WEST SUSSEX COUNTY COUNCIL CONSULTATION

TO:	Arun District Council FAO: Mr S Davis
FROM:	Highways, WSCC
DATE:	03/08/2018
LOCATION:	Rear of 94-100, Hook Lane, Rose Green, Bognor Regis, PO22 8AT
SUBJECT:	BR/139/18/OUT Outline application with some matters reserved for the demolition of 1 No. existing dwelling to form access for 6 No. residential dwellings.
DATE OF SITE VISIT:	
RECOMMENDATION:	☒ Advice ☐ Objection ☐ Modification ☐ No Objection ☐ More Information ☐ Refusal
S106 CONTRIBUTION TOTAL:	£N/A

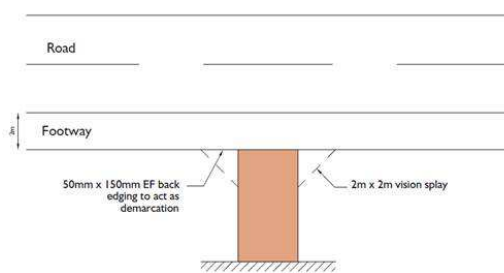
The proposed access adjoins the highway at Hook Lane, a D class residential road subject to 30mph speed restrictions. Hook Lane ends approx. 50m east of the proposed point of access and adjoins Brook Lane a private road not maintained by WSCC. Vehicular movements in the vicinity of the proposed are anticipated to be low speed and movements associated with visitors or residents of Hook Lane.

The applicant has stated within the application form their intention not to have this new road adopted by WSCC. The access takes the form of a 4.8m wide shared surface arrangement which is considered suitable to allow for two vehicles to pass one another

safely. It is considered that the access works can be undertaken under a minor works license, in agreement with the Arun Area Officer, Informative is included below.
